**STAFF REPORT  
HISTORIC AND CULTURAL LANDMARKS COMMISSION  
CITY OF FORT WORTH, TEXAS**

**DATES:** October 10, 2016

<b>REQUEST</b>	Certificate of Appropriateness
<b>APPLICANT/AGENT</b>	Murrin Bros 1885 Ltd.
<b>LOCATION</b>	2408 N. Main Street
<b>ZONING/ USE (S)</b>	PD 1017/HSE
<b>NEIGHBORHOOD ASSOCIATION</b>	Stockyards

<b>REQUEST</b>	Certificate of Appropriateness
<b>APPLICANT/AGENT</b>	Fort Worth Heritage Development LLC
<b>LOCATION</b>	122 E Exchange Avenue
<b>ZONING/ USE (S)</b>	PD 1017/HC
<b>NEIGHBORHOOD ASSOCIATION</b>	Stockyards

Proposed West Elevation

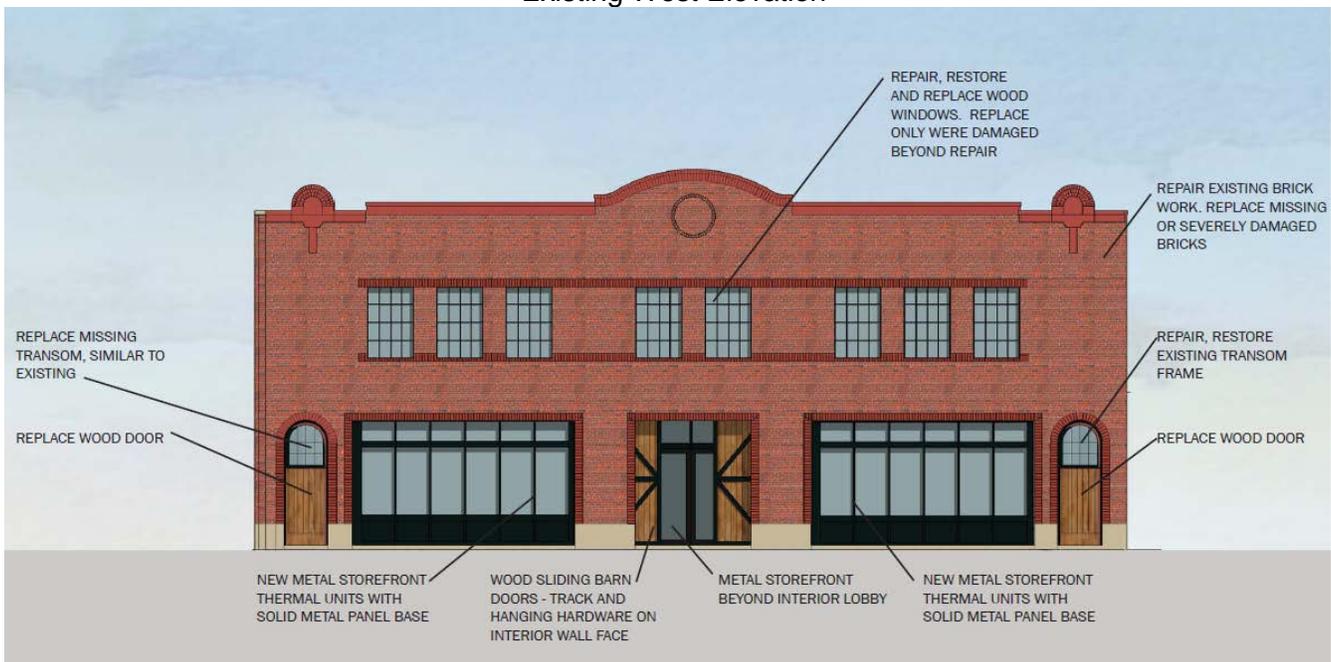
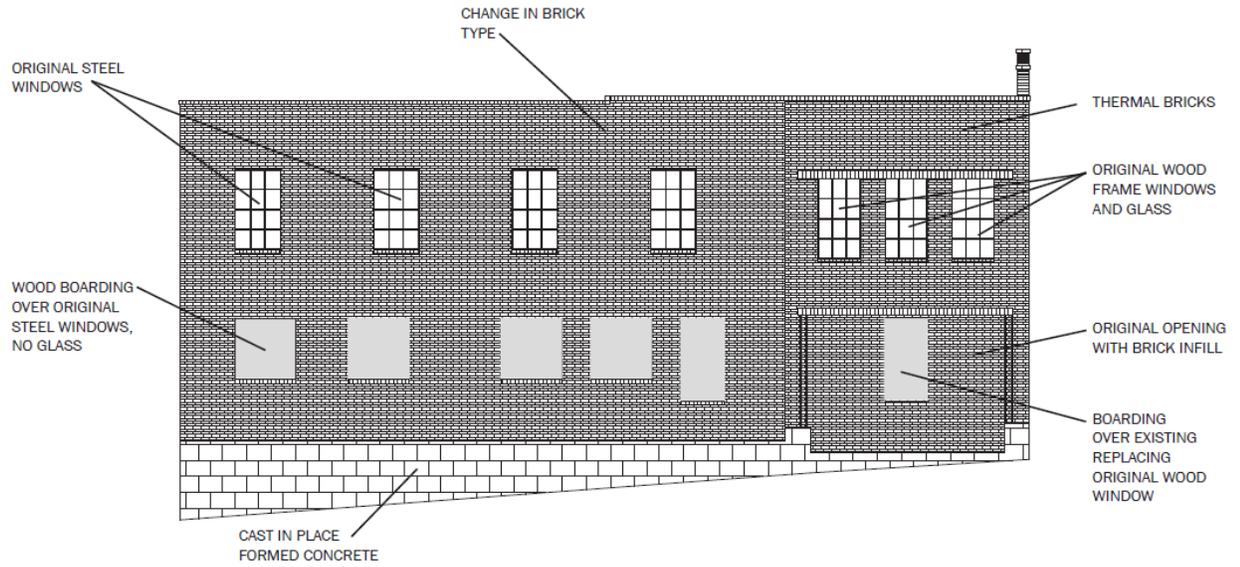
The proposed N. Main Street façade intervention involves the restoration of original openings and the rehabilitation of storefronts and the main entrance door. The proposed work is considered to be consistent with the *Secretary of the Interior's Standards for Restoration* in relation to window openings and with the *Secretary of the Interior's Standards for Rehabilitation* in relation to Storefronts and Entrances, and is an important undertaking that will contribute to strengthening the historic character and significance of N. Main Street.

Existing East Elevation

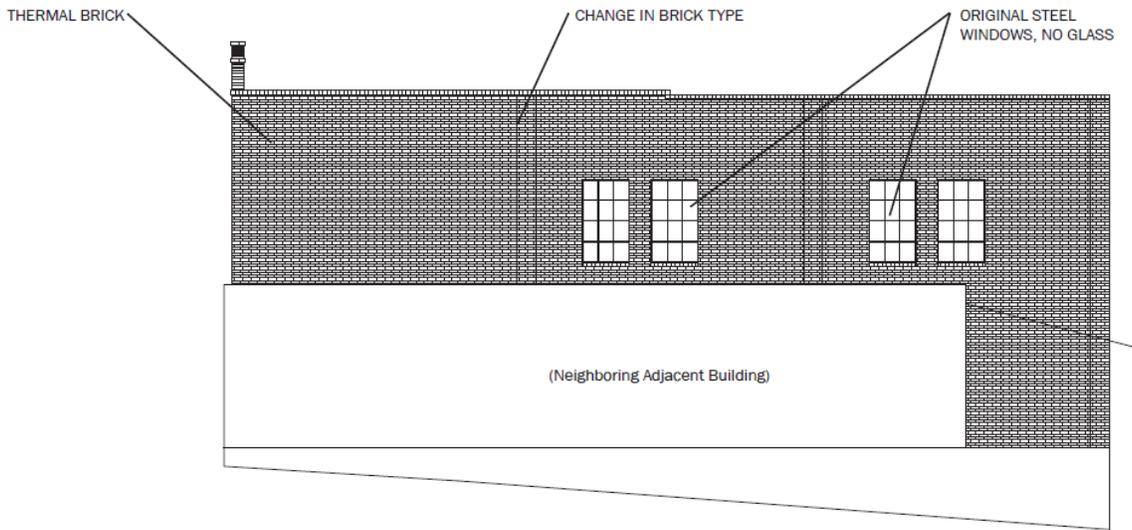
The proposed new structure and enclosure for the building's east façade includes the construction of a roof over the remaining structure while leaving as much of the historic fabric in place as possible. The proposed east elevation uses large amount of glazing and simple steel structural elements including exterior decks that open up to Marine Creek and Saunders Park. This is an important and beneficial aspect to the development - capitalizing on its strategic relationship to Marine Creek may achieve wider district objectives such as the revitalization of the underutilized Saunders Park.

This work involves replacing an entire masonry wall that was substantially destroyed by a wind storm, using a different design approach and materials. In relation to the proposed approach, we might revisit Standard 9 above. Since the proposed glazed wall consists of related new construction that does not destroy remaining historic materials that characterizes the Masonic Lodge and Stage Coach; the proposed work is differentiated from the old; and the proposed work is compatible with the massing, size and scale of the historic building, the proposed glazed wall and associated new work can be said to be consistent with *Secretary of the Interior's Standards for Rehabilitation* in relation to related new construction.

**That the Application for a Certificate of Appropriateness to undertake structural and foundation repair, rehabilitation of existing windows, reinstatement of original openings, construction of a new roof and enclosure for the building's east façade be approved subject to the following conditions:**

1. That condition assessments for historic fabric proposed to be replaced be provided;
2. That a materials and methods specification for the repair of historic masonry be provided; and
3. That a Temporary Protection Plan, which identifies potential risks and mitigation measures to be undertaken for the remaining historic walls be provided.

Elevations

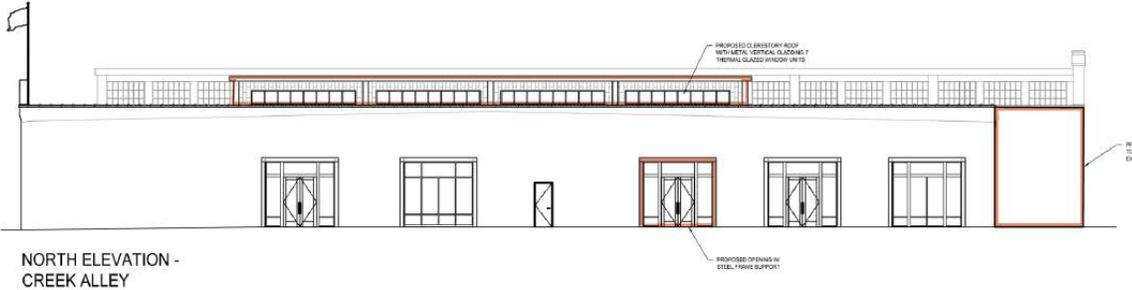
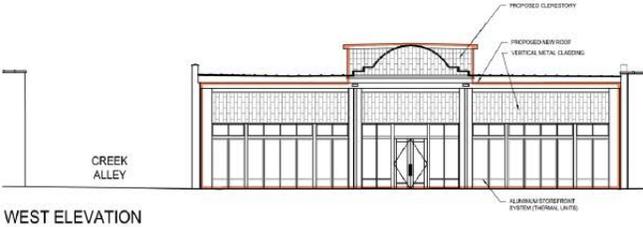
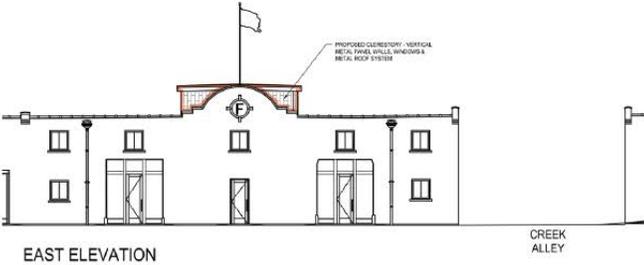
The proposed new opening on the north elevation of Barn F is consistent with the recently-proposed character along Mule Alley. Care is however, warranted, in relation to the potential for adverse cumulative effects arising from the number and size of openings. A sound preservation principle that seeks to “do as much as necessary and as little as possible” is therefore relevant in this case. Cutting-in a new opening may be considered an irreversible intervention. The demonstrated need for such an intervention, given the extent of previously-approved similar interventions and the impact on the structural stability of the wall should be carefully substantiated.

The proposed aluminum storefront is atypical in a building that is characterized by sparsely-located punched openings set into a masonry wall. That the proposed work is atypical does not inherently imply that it is inappropriate. Given the predominant character of the Horse and Mule Barns, the location of the proposed work serves as a form of mitigation for the contrast that it seeks to achieve.

The proposed glazed replacement wall is compatible with the size and scale of the Horse and Mule Barns, however, the materials and color are intentionally different, with the aim of contrasting the new work from the historic. For this approach, we should revisit Standard 9 above. Since the proposed glazed wall consists of related new construction that does not destroy remaining historic materials that characterizes the Horse and Mule Barns; and the proposed work is differentiated from the old, and is compatible with the massing, size and scale of the historic building; the proposed glazed wall and associated new work is consistent with *Secretary of the Interior's Standards for Rehabilitation* in relation to new construction.

- 1. That condition assessments for historic fabric proposed to be replaced be provided;**
- 2. That a materials and methods specification for the repair of historic masonry be provided;**
- 3. That the applicant work with Staff to ensure that the final design includes substantive evidence of the original footprint and massing of Barn F after the removal of the concrete-block west wall;**

- 4. That the applicant consider the number of new openings being cut into the masonry walls based on substantiated need; and**
- 5. That a Temporary Protection Plan, which identifies potential risks and mitigation measures to be undertaken for the remaining historic walls be provided.**
